## **Release Note**

**Software Version: 2.8.1.6305**

**Models: X1、X2、X2C、X3S、X4**

**Date: 2018-12-06**

### 2. Added SIP Server master backup function

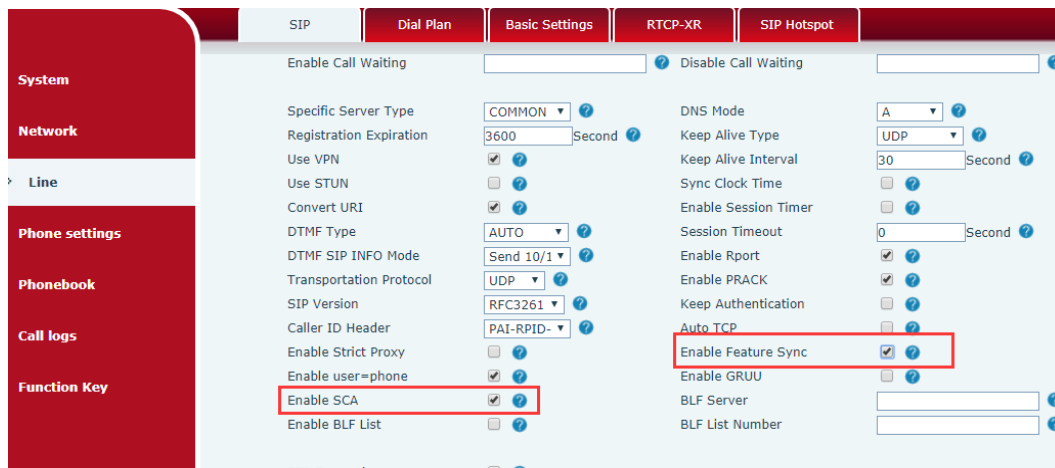
**Description:** Add the sip backup server function, SIP Server1 is the primary server, and SIP Server2 is the backup server. The group function is extended to implement the server primary backup function. The configuration of Server2 is set to the backup line, and then the main line and the backup line are divided into one group. The backup switching mechanism remains the same. The main line is registered first. If the main line registered fail, switch to backup line registration. When registered to the backup line, if the main line registration is successful, it will switch back to the main line. The web page configuration is as follows:

2. Optimized the length of the Server Address URL under Static Provisioning Server module to 256.

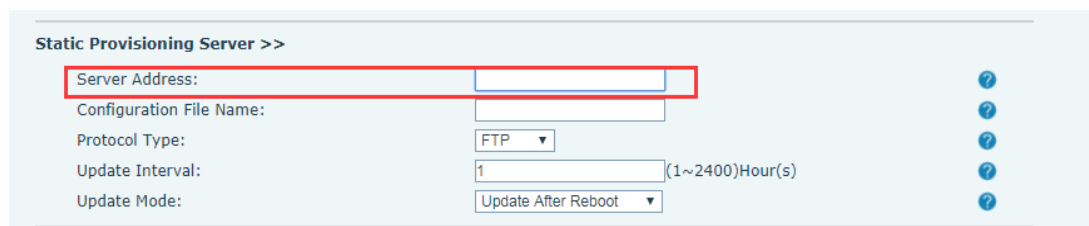
**Description:** On the web System >> Auto Provision page, extended server address URL to 256 bits, which was previously 92 bits.
